File            SPR-1995-088

Project Name: Retail Center

TITLE HEADING: Site Plan Review - Retail Center

LOCATION: 104 Orchard Avenue (NE corner 1st & Orchard)

# EXHIBIT "A"

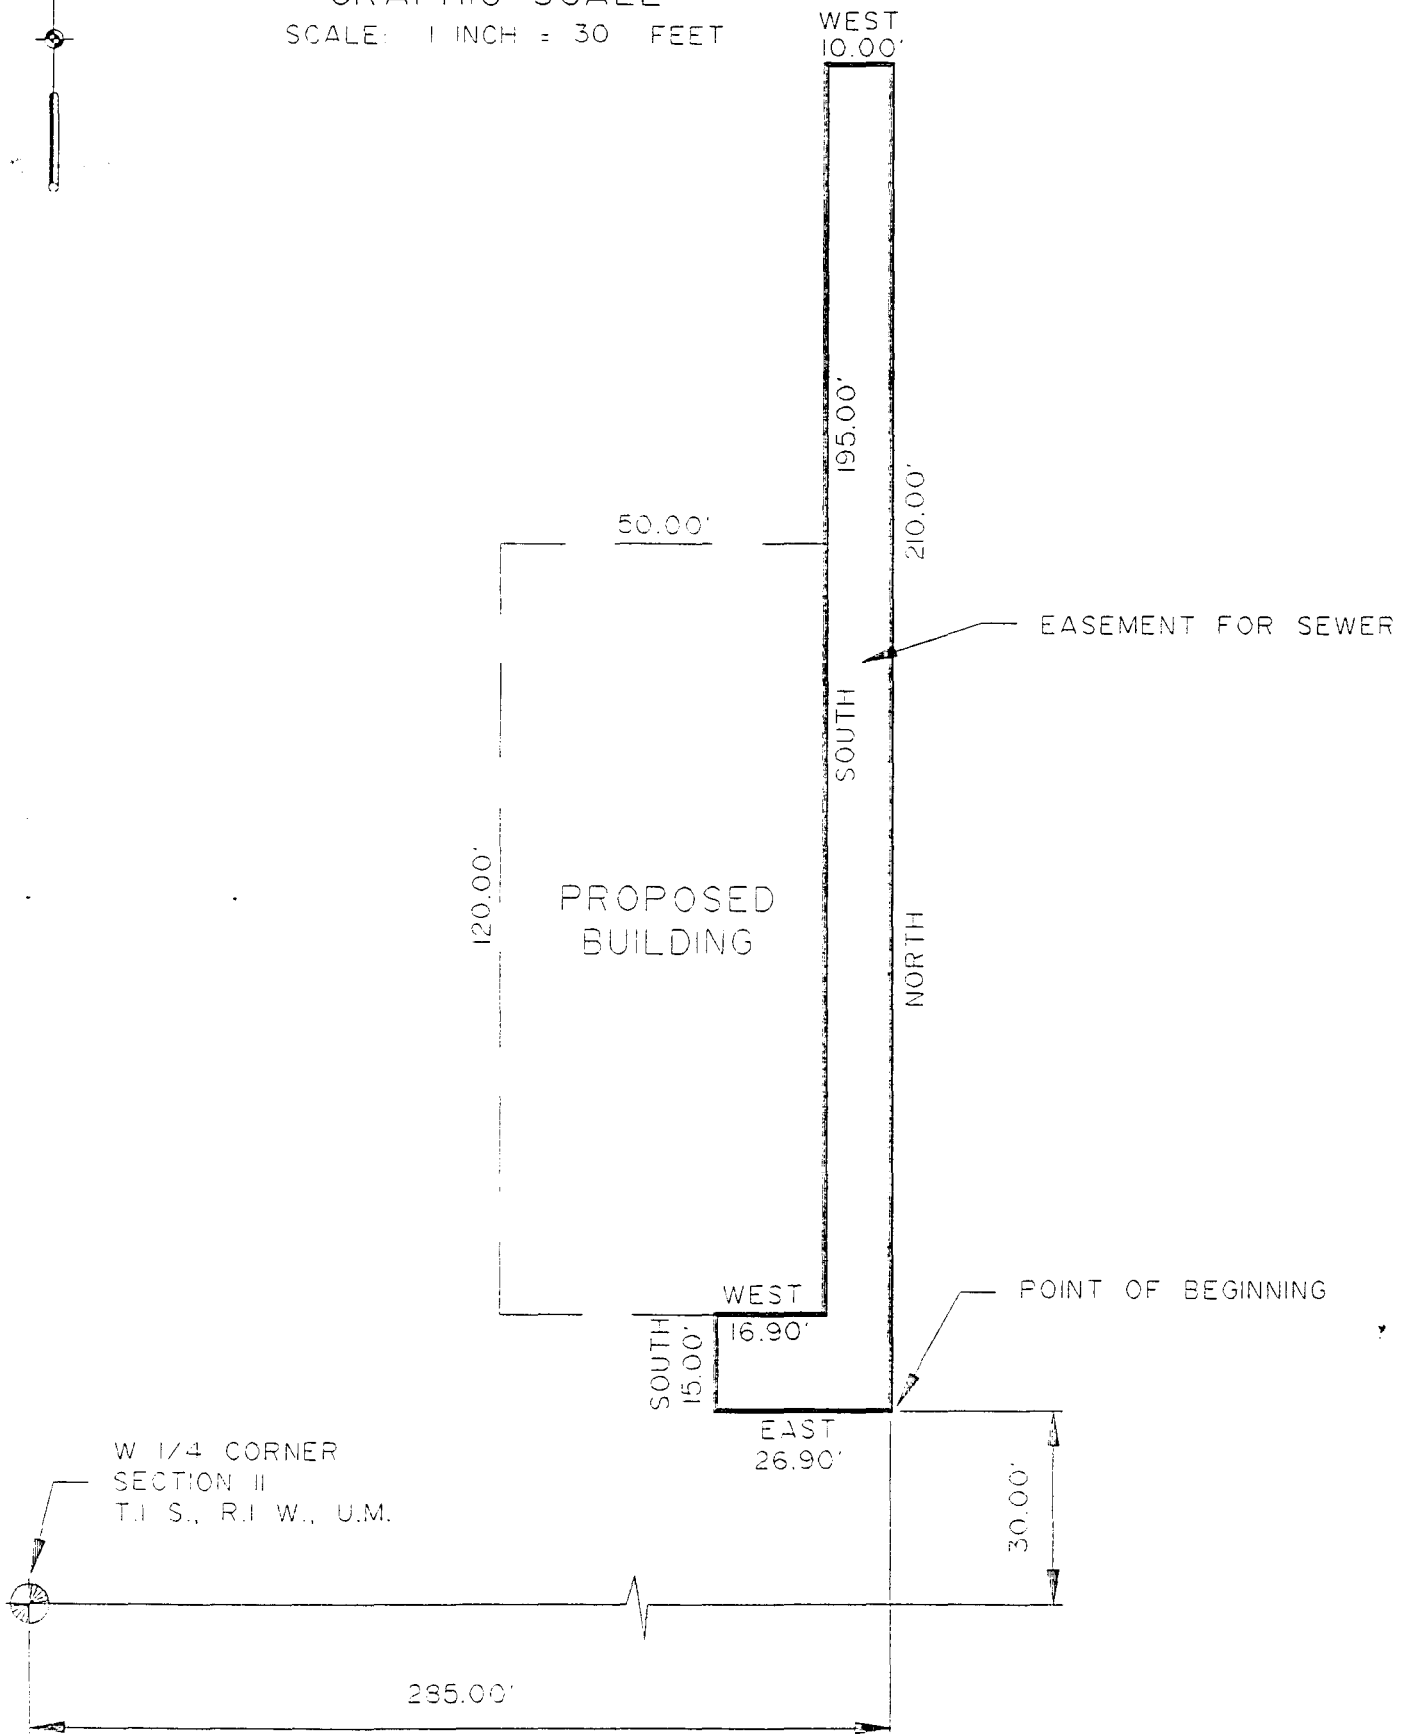
1. U.S. West will need a utility easement across property - the north side behind the new building to east side of property (see attached sketch).
2. New or additional telephone facilities necessitated by this project may result in a "contract" and up-front monies required from developer, prior to ordering or placing of said facilities. For more information please call Max Ward at 244-4721.

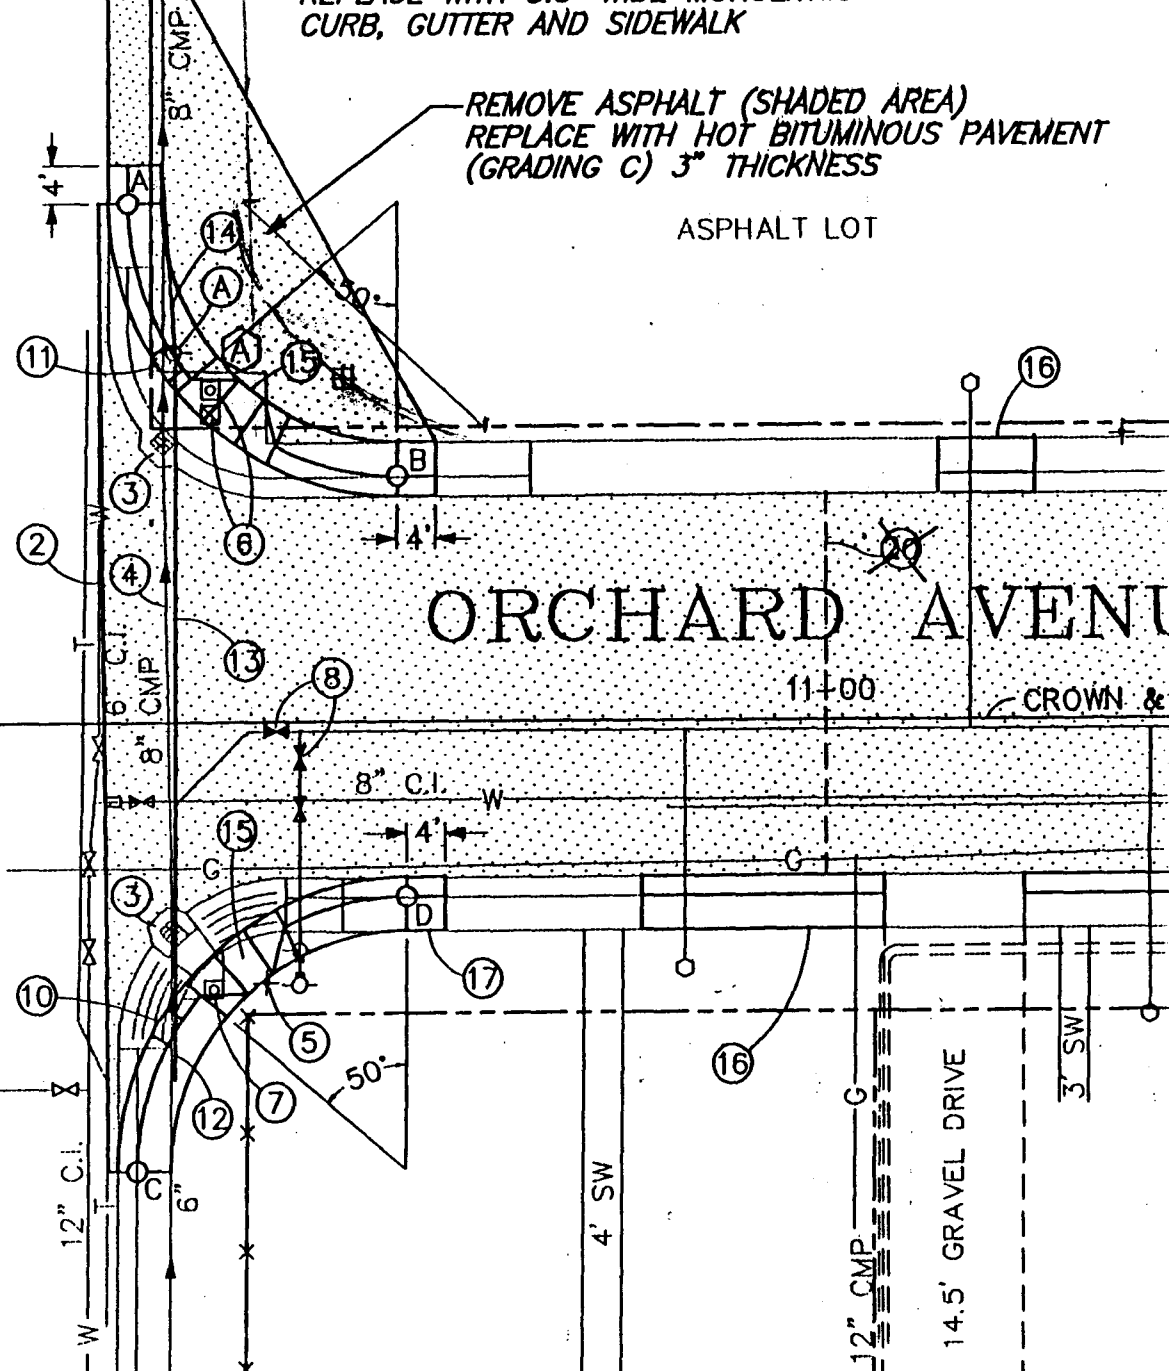
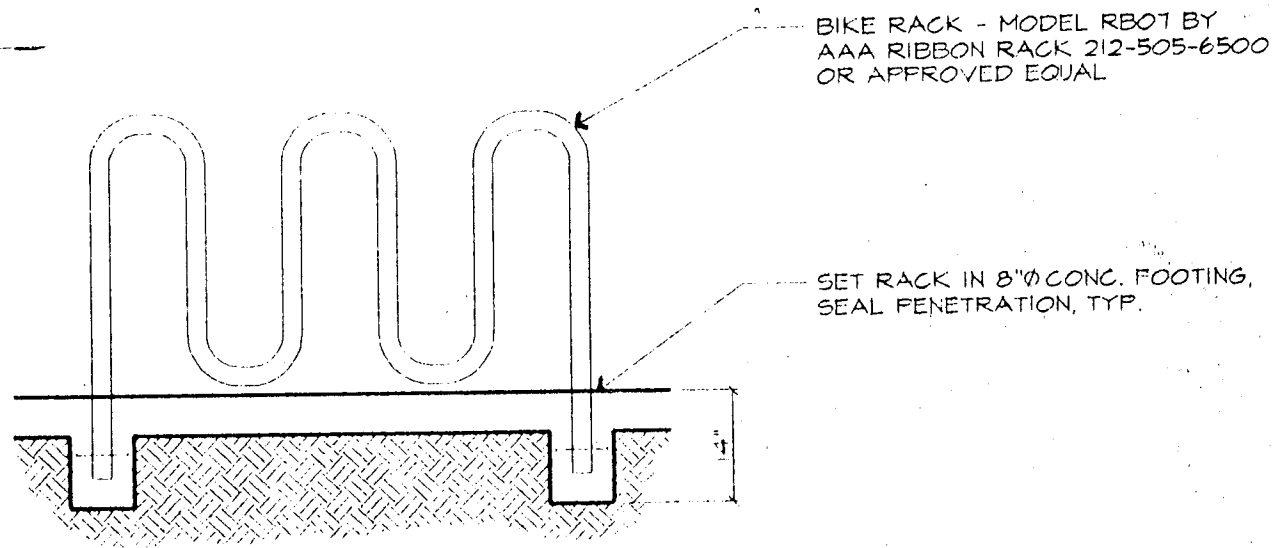
- 1. Please provide information on the previous use of this site including square footage and type of business which existed prior to the fire for the TCP credit.

- 2. Drainage - no fee due to no increase in runoff.
- 3. Please label the new sewer easement on the site plan.
- 4. It appears as though additional right-of-way on 1st Street is needed for intersection widening. The drawing needs to accurately reflect the existing property boundaries and rights-of-way. We will need sufficient right-of-way so that there is forty feet from centerline to the property with a triangular piece at the corner with Orchard with 23' legs. Highlighted drawing is attached.

- 5. The angled parking needs to be 90 degree parking to function properly.
- 6. Two handicap spaces are required. These must be labeled and dimensioned as per the City Standard drawings. They must also be signed and marked appropriately.

- 7. The location of the dumpster needs to be shown.
- 8. The headgate structure in the middle of the parking lot needs to be protected from traffic. Please show on the drawing how this will be handled.

- 9. It appears the parking requirement will be slightly short of the required when the parking is reconfigured to meet the handicap space and adjacent maneuvering area.

1. ✓ Landscaping Plan incomplete - see attached Landscape Plan checklist for missing items. Also see attached Code regarding planting size requirements.

3. ✓ Section 5-5-1H of the Code requires that bicycle parking be provided sufficient to hold three bicycles or the number of bicycles equal to ten percent of the required off-street parking spaces for the use, whichever is greater. Please revise Site Plan to indicate location of parking (which should be convenient to entrance to stores) and provide a bicycle rack detail (sample attached).

5. ✓ Parking ratio for retail uses as per Code is 1 space/200 square feet. Based on the building area proposed, required parking is 42 spaces whereas only 36 spaces are provided.

6. ✓ Plan should be labeled as "Site Plan/Grading and Drainage Plan/Landscaping Plan" as per SSID standards, NOT as "Plot Plan".

7. ✓ The curb cut proposed to be removed must be clearly labeled. Also provide a Detail Sheet (as per SSID manual) which contains the City standard monolithic curb/gutter/sidewalk section. A Development Improvements Agreement (DIA) (attached) must be completed to guarantee all work in the public right-of-way. Directions for

- 8. ✓ The sidewalk along the east side of the southern building must be clearly labeled.
- 9. ✓ Please identify the extent of the new paving and construction.
- 10. ✓ The City sewer easement must be clearly identified on the plan.
